APPLICATION NO.	FILING DATE	FIRST NAMED INVENTOR	ATTORNEY DOCKET NO.	CONFIRMATION NO.
09/615,794	07/13/2000	Dong-Gyu Kim	06192.0141.NPUS00	5256

Office Action Summary

DETAILED ACTION

FIG. 10

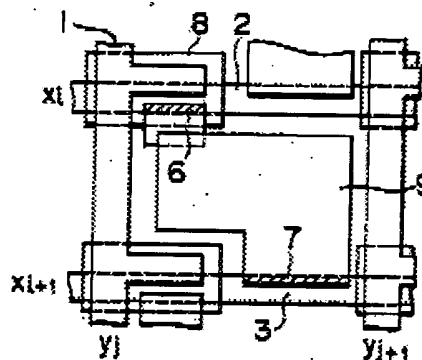
As to claims 1-3, Tsukada discloses in Figure 10 his fourth embodiment (col. 8, lines 38-62) a liquid crystal display, comprising:

a plurality of gate lines, 3, formed at the first substrate to transmit scanning signals;

a plurality data lines, 1, crossing over the gate lines to transmit picture signals;

a storage capacitor, 7, formed between said pixel electrode and the previous gate line (col. 6, lines 40-48).

As to claims 9-12, Tsukada discloses in Figure 10 his fourth embodiment (col. 8, lines 38-62) a liquid crystal display, comprising:
a first insulating substrate;
a plurality of gate lines, 3, formed at the first substrate to transmit scanning signals;

a pixel demarcated by the gate lines and the data lines (per Figure 10), the gate lines demarcating the pixels into rows, and the data lines demarcating the pixels into columns;

FIG. 6

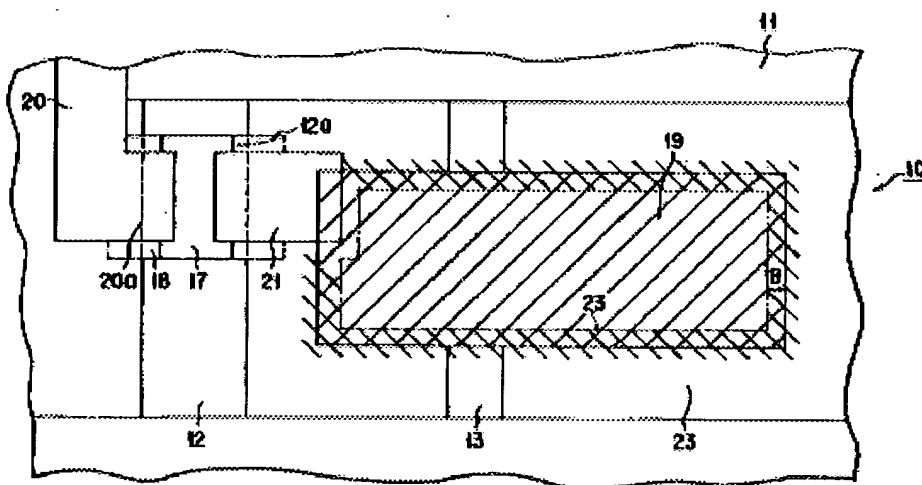
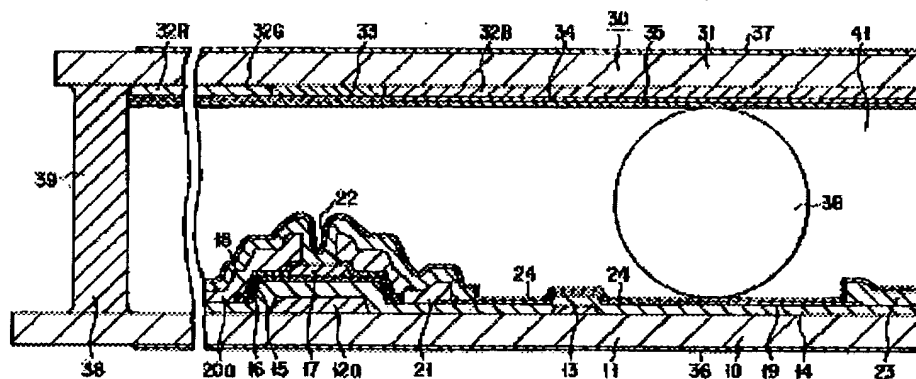
Dohjo teaches, in Figures 6 and 5, the use of a protecting film, 23 (Applicant's black matrix), wherein an aperture ratio is lowered in the peripheral portions of the display near the sealant and near the closing agent (Applicant's opening ratio of each pixel at the first pixel row is different from the opening ratio of the pixels at the other

pixel rows) to prevent the development of deterioration of image quality of the peripheral portions while preventing a lowering of the aperture ratio of the main display pixel electrodes (col. 9, line 58 through col. 10 line 5).

Dohjo is evidence that ordinary workers in the art of liquid crystals would find the reason, suggestion, or motivation to add a black matrix, wherein an opening ratio of each pixel at the first pixel row is different from the opening ratio of the pixels at the other pixel rows to prevent the development of deterioration of image quality of the peripheral portions while preventing a lowering of the aperture ratio of the main display pixel electrodes.

Dohjo teaches, in Figures 6 and 5, the use of a protecting film, 23 (Applicant's black matrix), wherein an aperture ratio is lowered in the peripheral portions of the display near the sealant and near the closing agent (Applicant's opening ratio of each pixel at the first pixel row is different from the opening ratio of the pixels at the other pixel rows) to prevent the development of deterioration of image quality of the peripheral portions while preventing a lowering of the aperture ratio of the main display pixel electrodes (col. 9, line 58 through col. 10 line 5).
